Subject: Certification of H-3 Flammable Storage Building at the Safety-Kleen Albuquerque, New Mexico, Branch

CERTIFICATION OF H-3 FLAMMABLE STORAGE BUILDING
ALBUQUERQUE, NEW MEXICO

INSTALLATION CERTIFICATION
H-3 FLAMMABLE STORAGE BUILDING

INTERIOR OF CENTER TRENCH (OUTLET PIPE TO FIREWATER CONTAINMENT TANK AT LEFT. INLET PIPE FROM SOUTH DOOR TRENCH AT RIGHT) (PICTURE TAKEN PRIOR TO MODIFICATION OF OUTLET PIPE)

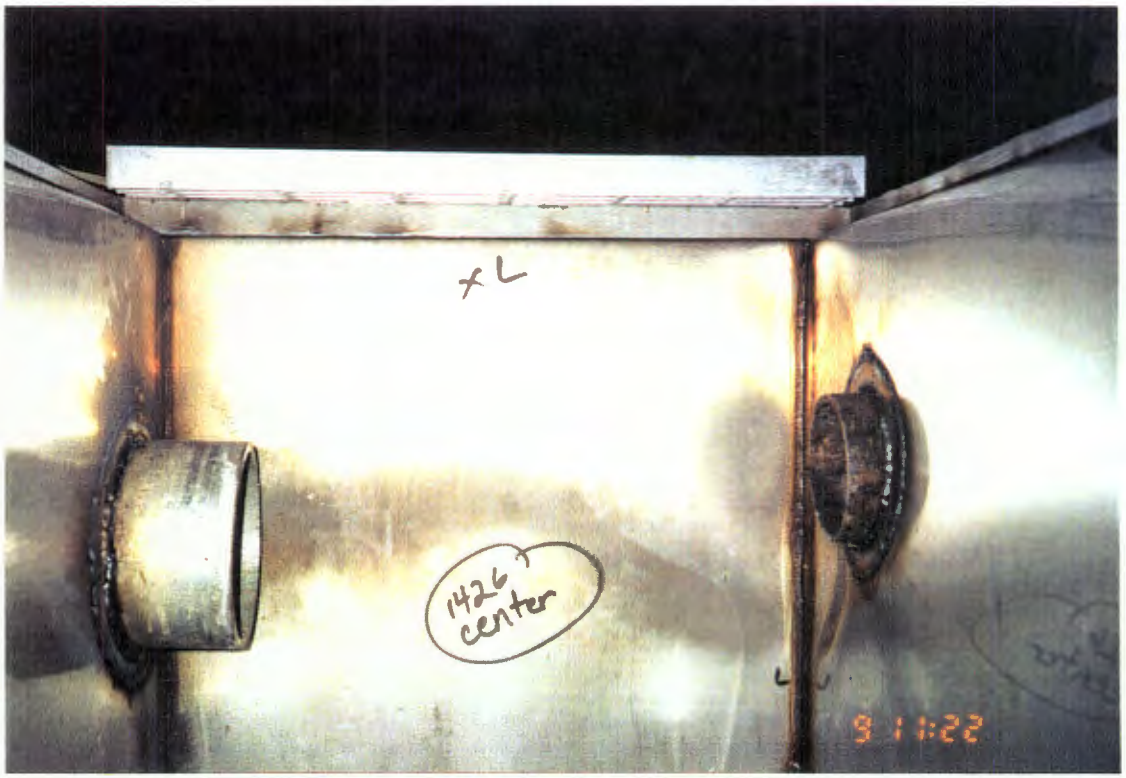
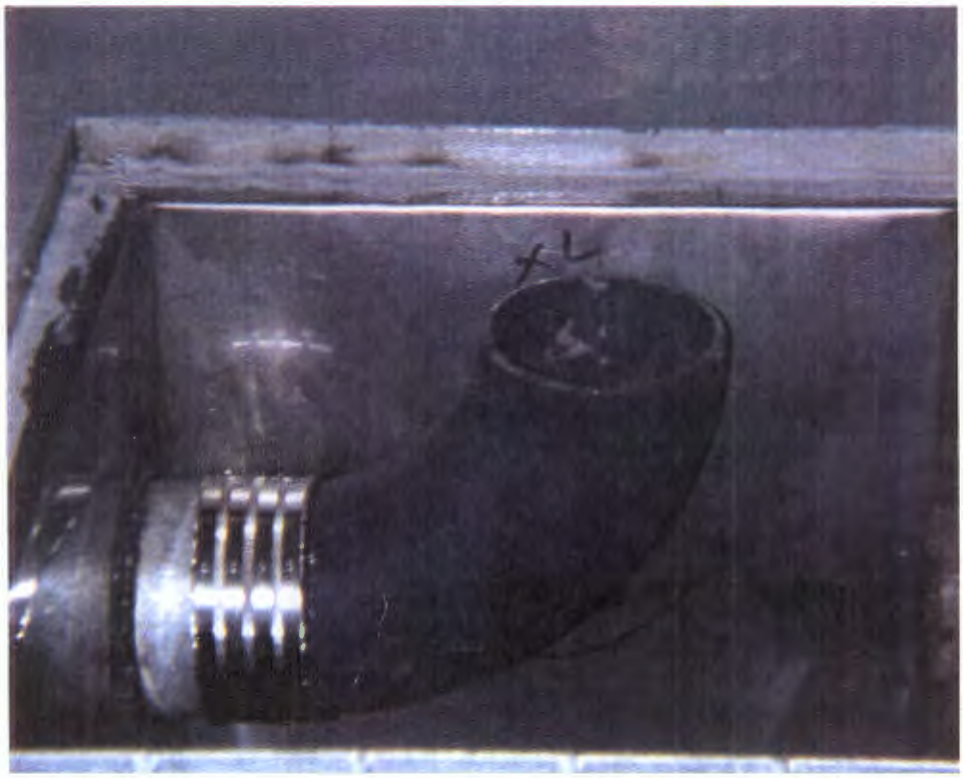
Inspection by TERA on April 9, 1992 revealed that the outlet pipe from the center trench was not installed above the door trench pipes as designed (See Plate 4 and Photo B on Plate 18). The contractor corrected this deficiency during April 10-13, 1992 as shown on Plates 8 and 19. A 90-degree elbow was installed to elevate the mouth of the center trench outlet pipe above the entrances to the door trench outlet pipes. A square of sheet metal was fastened to the underside of the grate to cover the open mouth of the pipe, which now faces upward. Thus, the firewater collection tank remains isolated from a potential 10% hazardous waste spill within the warehouse. With these modifications, the H-3 Building's secondary containment now appears to satisfy the design requirements of HWMR-6, Pt. V, sec. 264.175 (b)(2).
